NOTIFICATION

#0012

RELEASE DATE: 14/06/2024
EFFECTIVE DATE: 14/06/2024
SUBJECT: Equivalent hardware for Service Bulletin 24 and thread inspection
MODELS AFFECTED: All Sling aircraft affected by Service Bulletin 24
COMPLIANCE TIME: Immediately

Figure 1

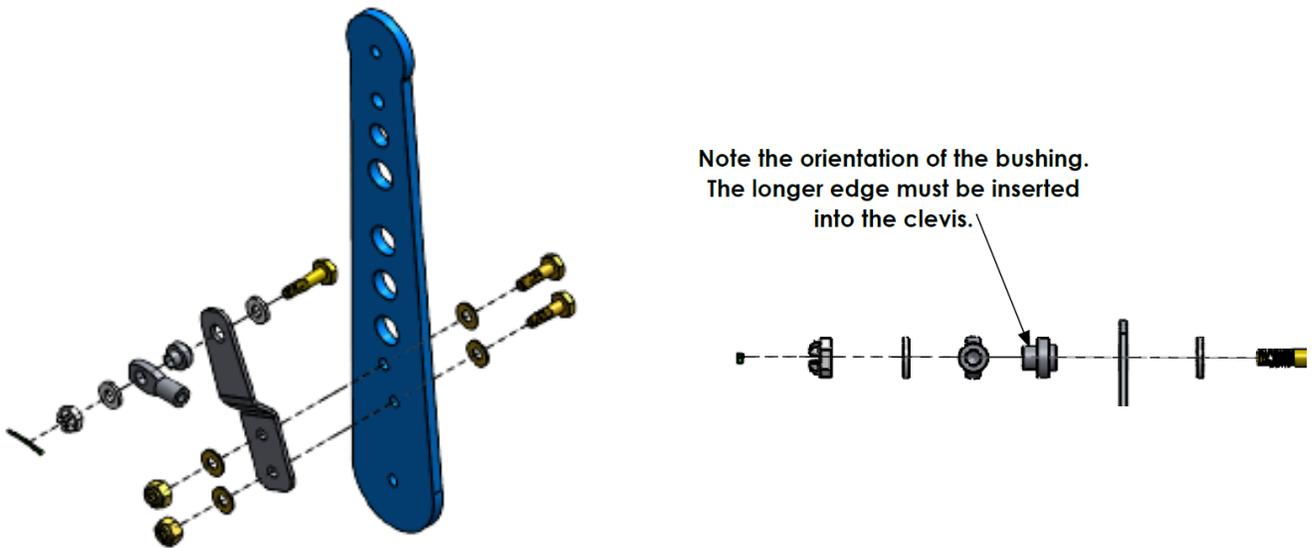
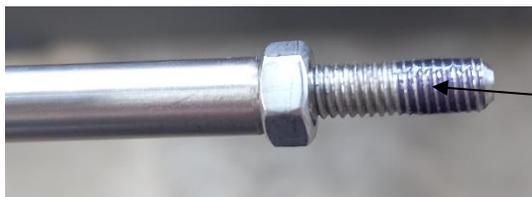
When installing the clevis using Hardware kit 2, it is attached using the castle nut and split pin as seen in Figure 1.
